Technical Memorandum for 505-513 West 43rd Street
CEQR No. 14DCP183M
ULURP Nos. N140407ZRM, 140408ZSM, 140409ZSM
April 16, 2015

Re: 505-513 West 43rd Street (CEQR No. 14DCP183M) -
Revisions to Amtrak rail ventilation system

Subject: Change in Courtyard Shaft Size for
Amtrak Empire Line Overbuild – 43rd St. to 44th St.

Figure
1

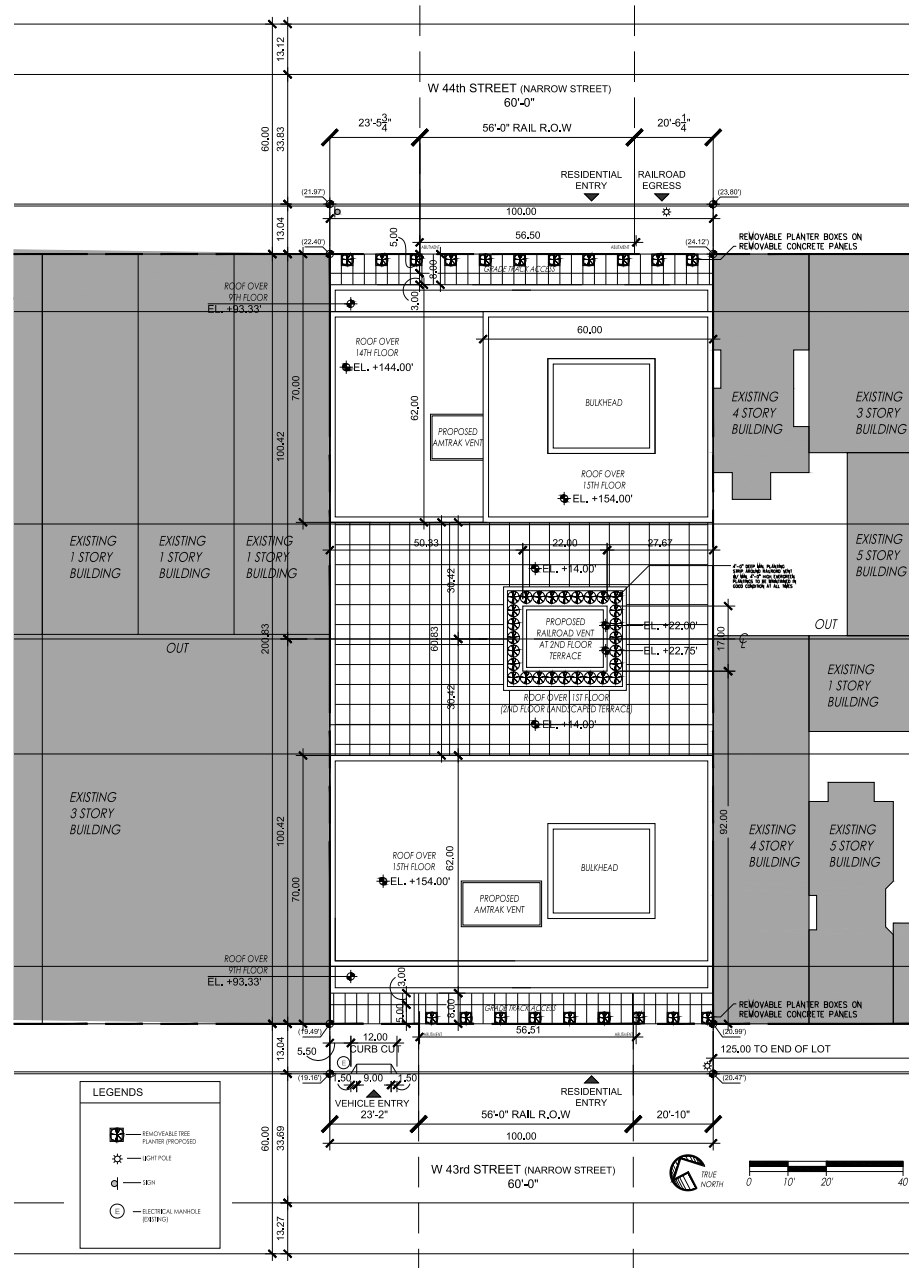
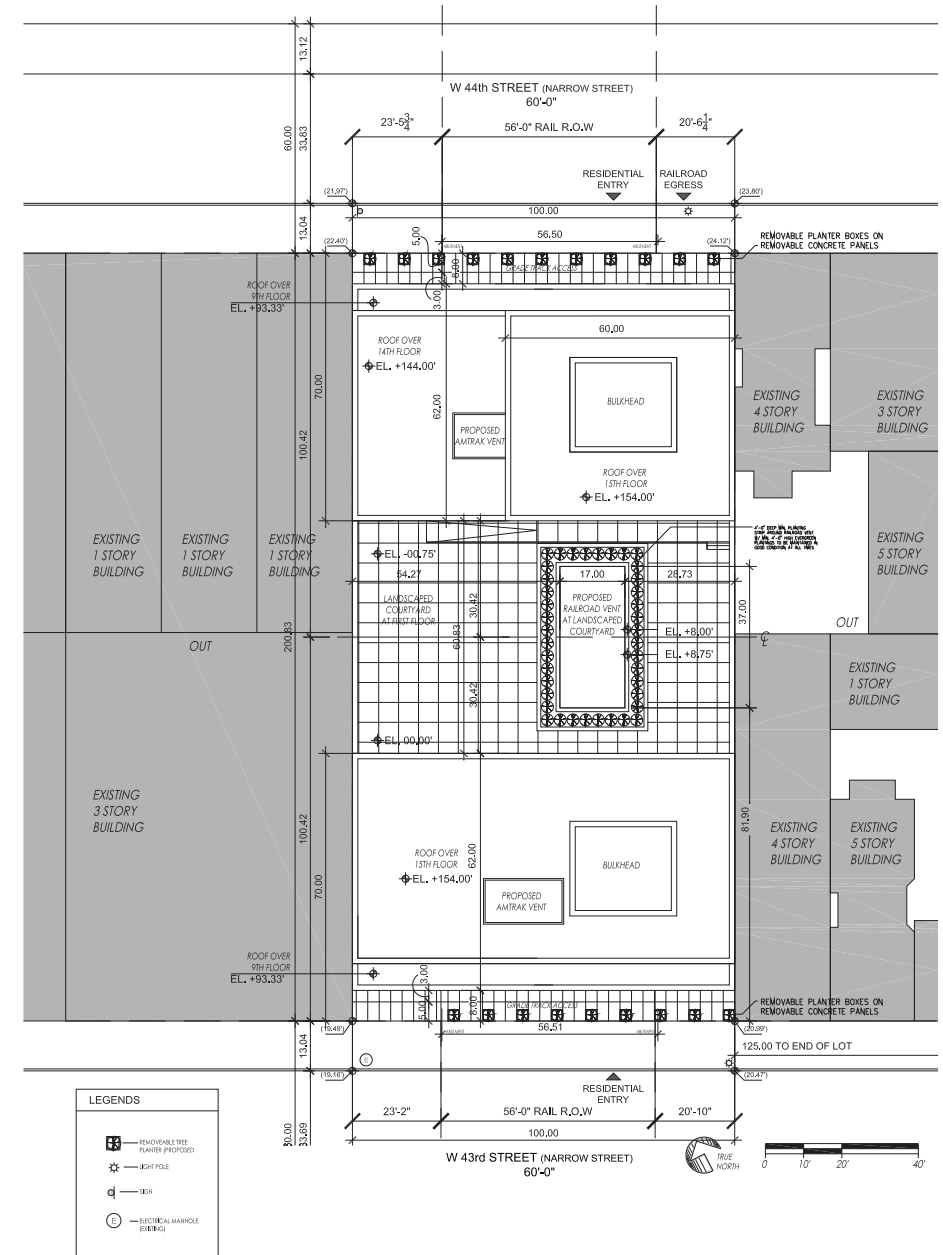
Based on review of the project by the City Council and design modeling subsequently required by Amtrak (see attached correspondence for more detail), the following modifications to the project are currently proposed (see also Figure 1):

- Increase the size of the passive emergency Amtrak vent from approximately 375 square feet (22 feet wide by 17 feet deep) to 630 square feet (17 feet wide by 37 deep)¹.
- Remove the parking (curb cut on West 43rd Street) and replace with approximately 1,458 square feet of residential floor area, approximately two dwelling units including one on-site affordable unit, resulting in an slight residential FAR increase (from 7.4 to 7.47)

The heights of the building segments would remain and the overall building envelope would not be expected to change. The active rail ventilation would be located at the roof level of both segments (154 feet). A full description of the modifications is included in the filing letter from the Land Use Committee of the City Council to the City Planning Commission dated April 16, 2015 (attached to this memo). A detailed site plan and building section and elevation drawings for the modified plan are also attached to this memo (See Drawings Z-9 through Z-11).

Z-10

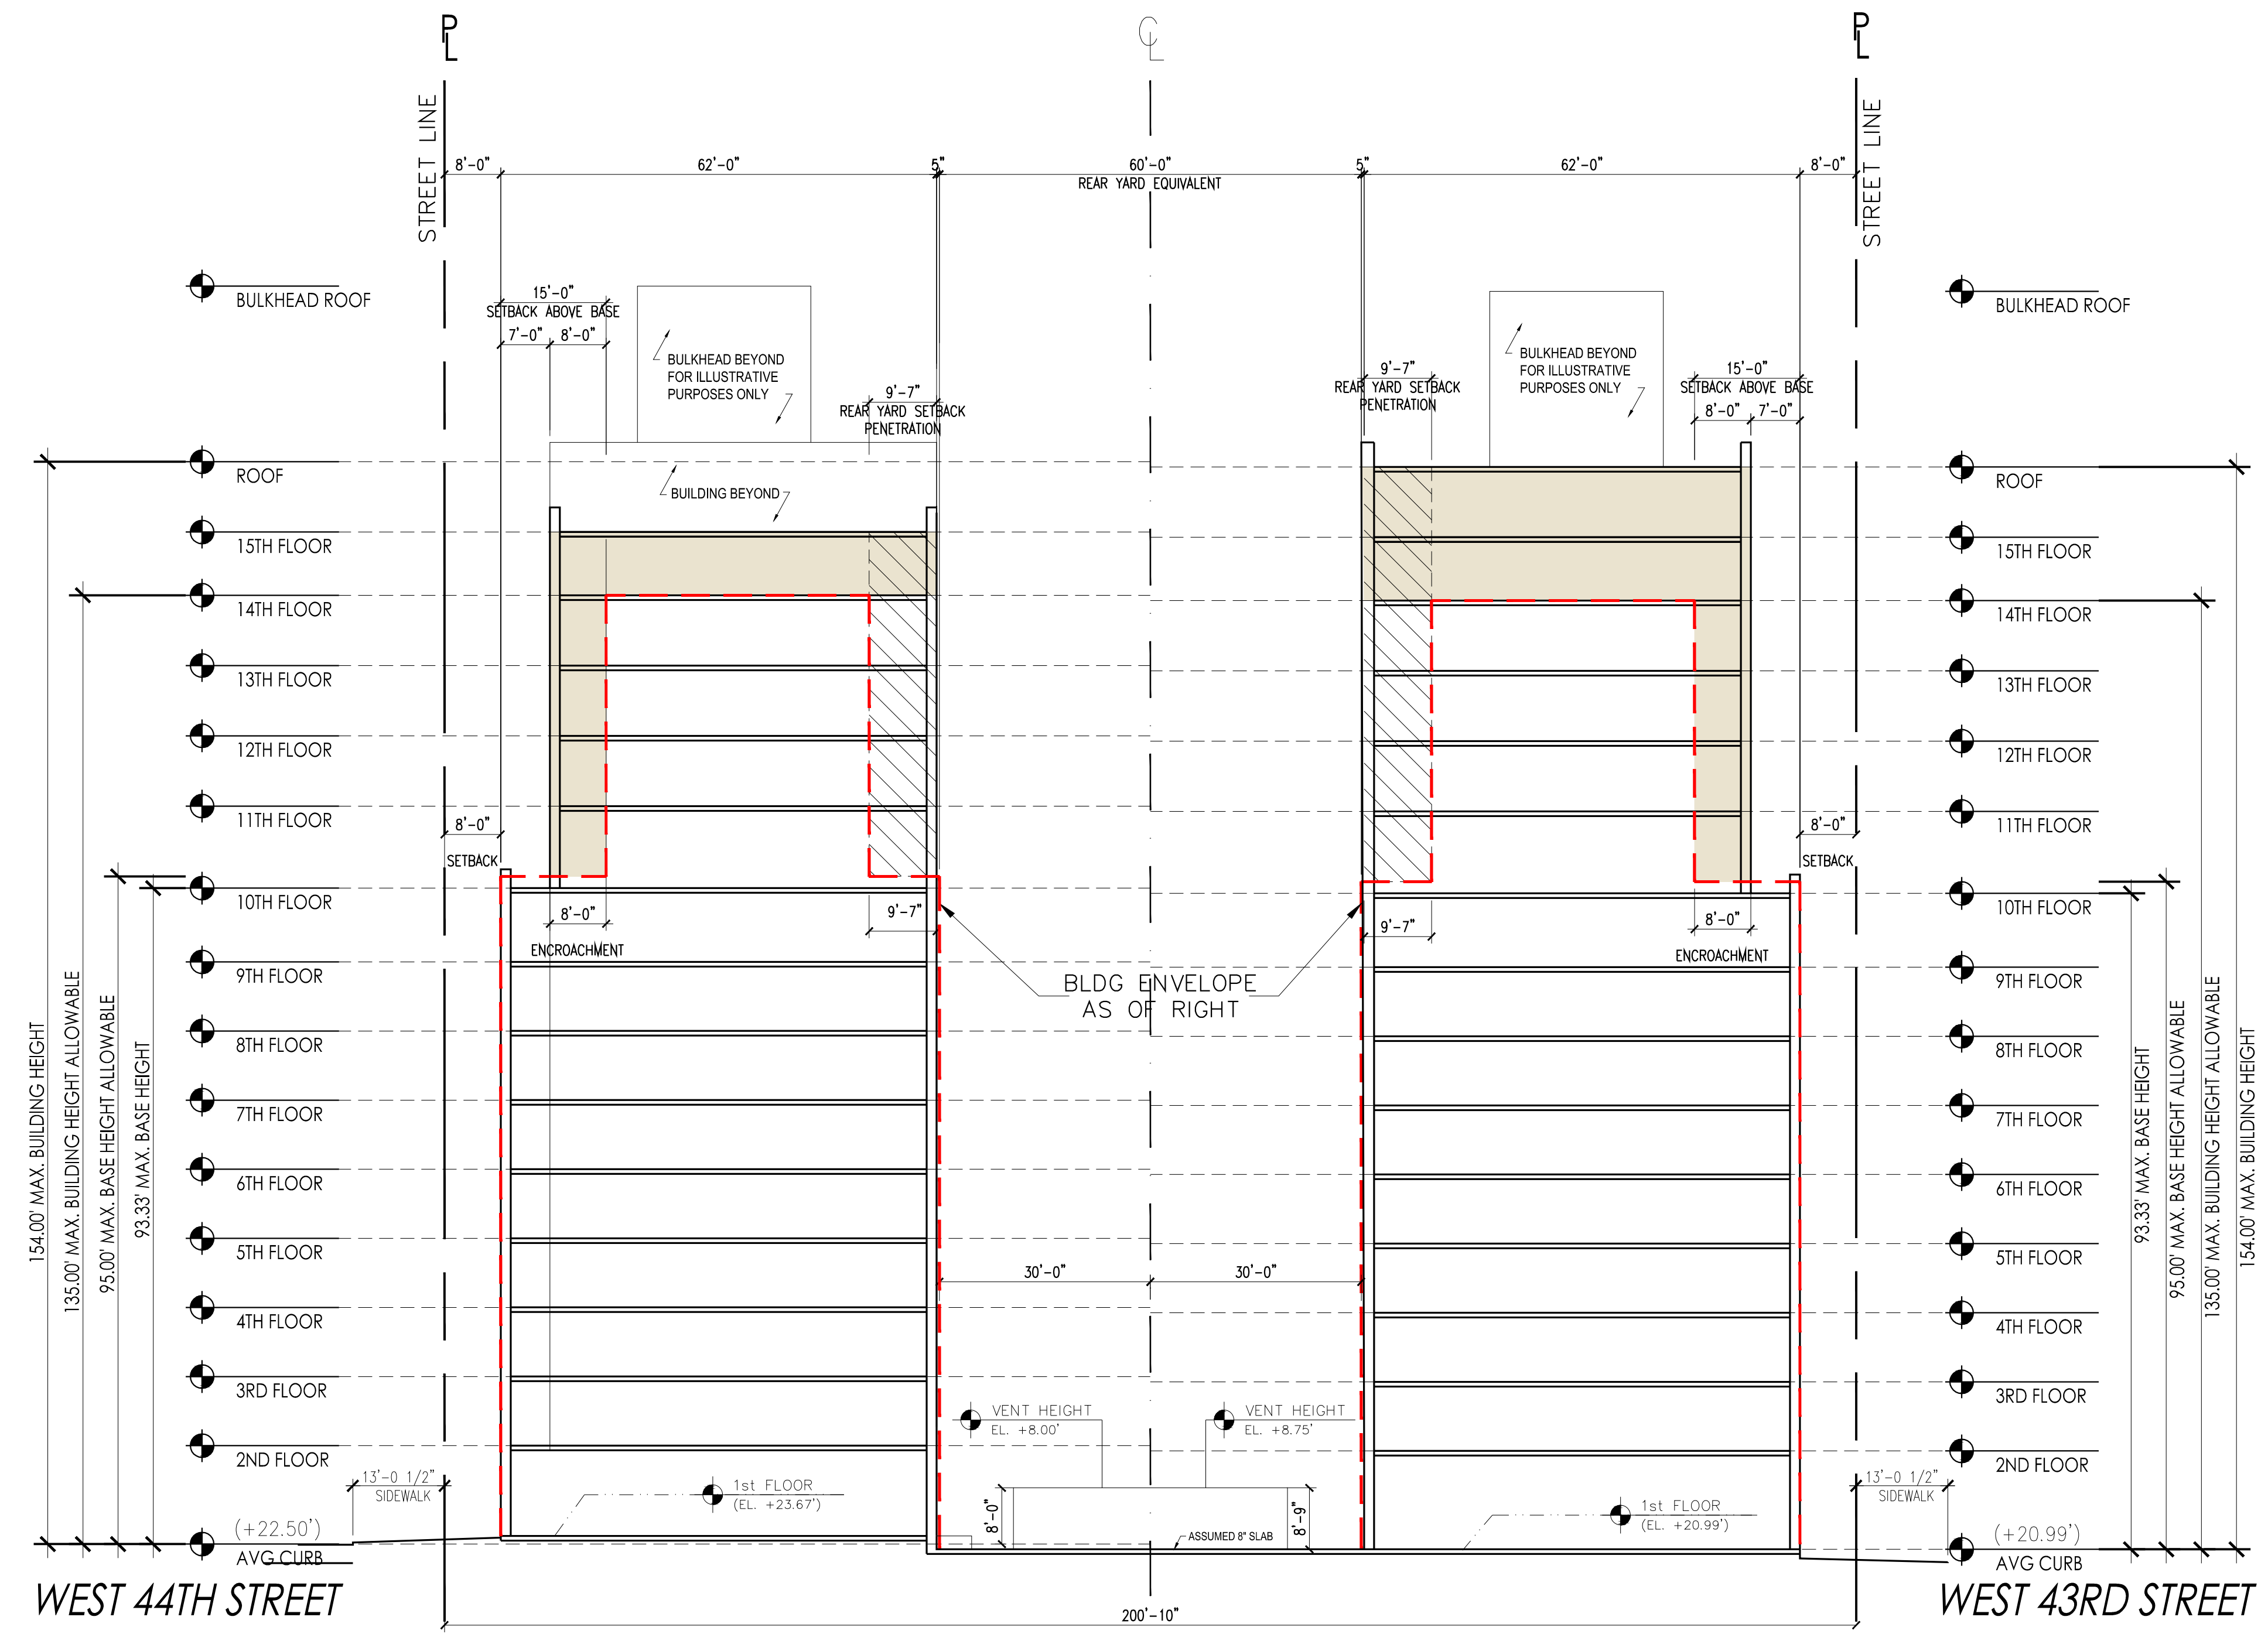
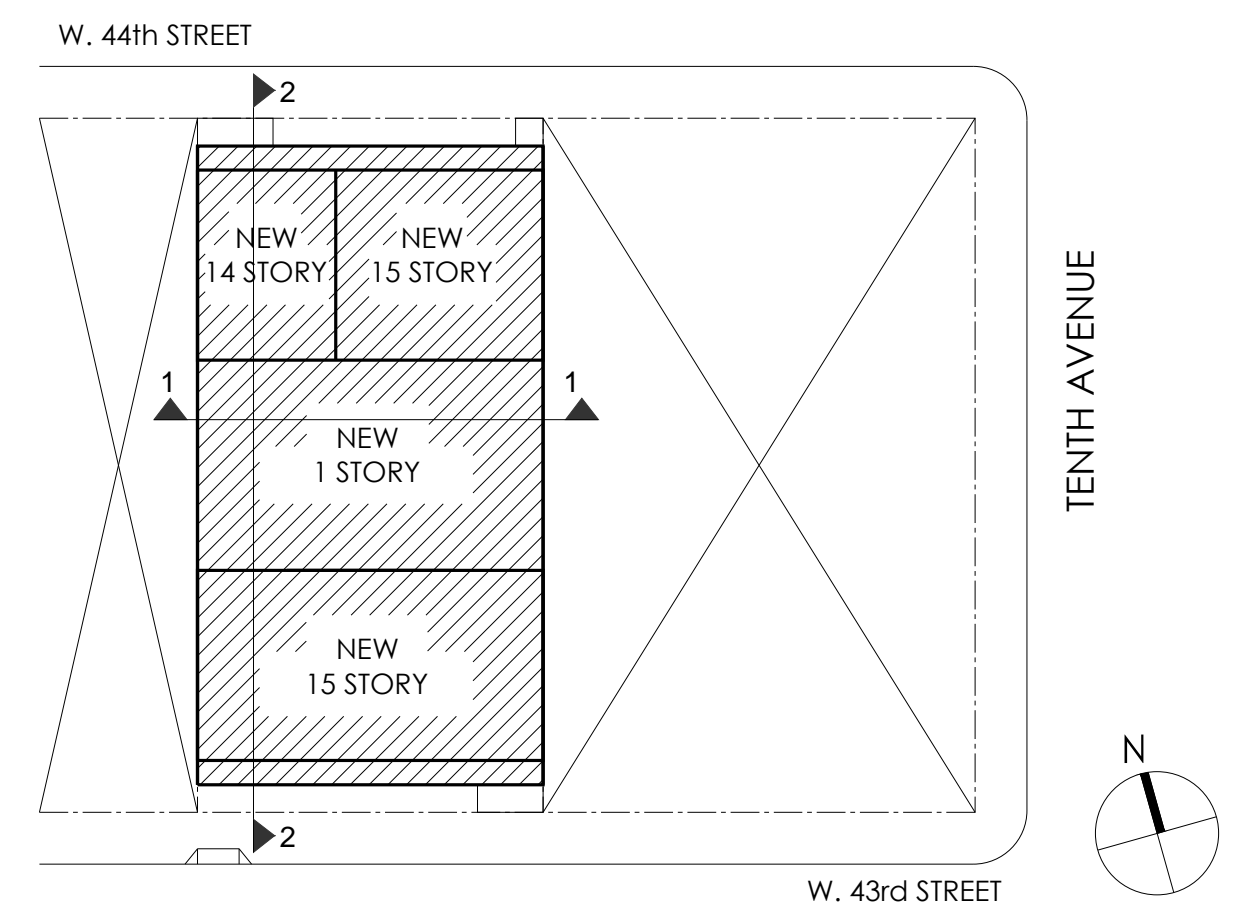
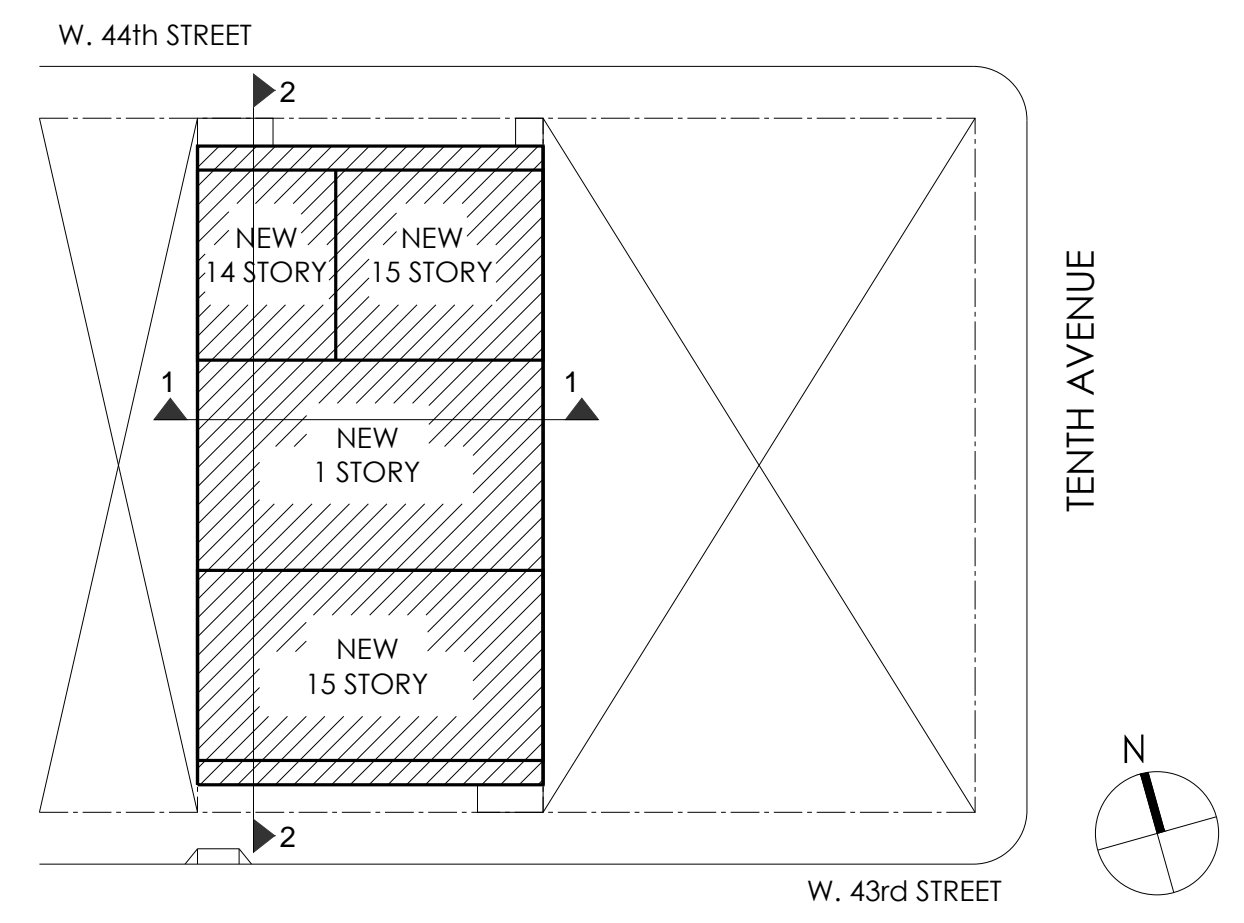
The recommended modifications consist of (1) elimination of the ground floor parking spaces in the proposed building, to be replaced, in part, by residential ground floor uses; and (2) increasing the size of the emergency vent in the rear yard of the development to satisfy Amtrak specifications which became known subsequent to the Commission's approval of these actions. Specifically, the modifications are as follows:
